Batz Phase 1 ARP ***REVISED 8/14/25***

The Hendricks County Surveyor's Office is looking to get quotes for phase 1 of the Batz ditch project which was approved through the Hendricks County Drainage Board as an ARP project.

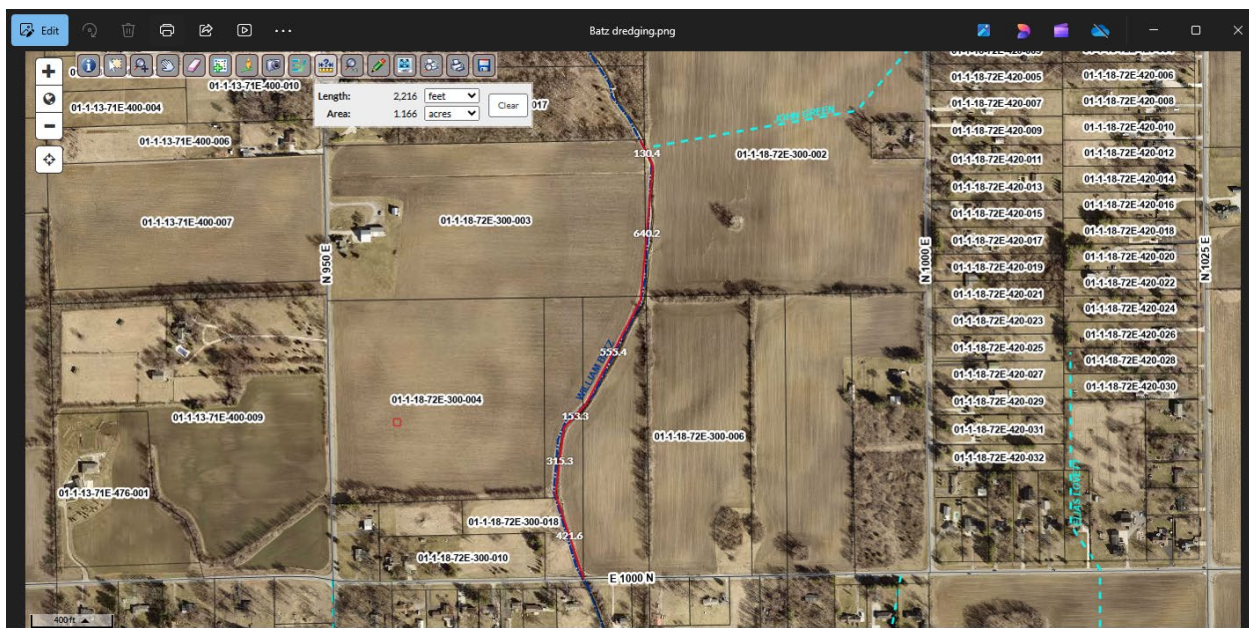
1. Starting at the north side of cr E 1000 N dredge approx.. 2,216' of ditch from the west side heading north past the John Green outlet.
2. Work to be done from the west side of the ditch.
3. Spread spoils along the top of bank within the easement in the field area.
4. Contractor must come back to seed and straw grassy areas.
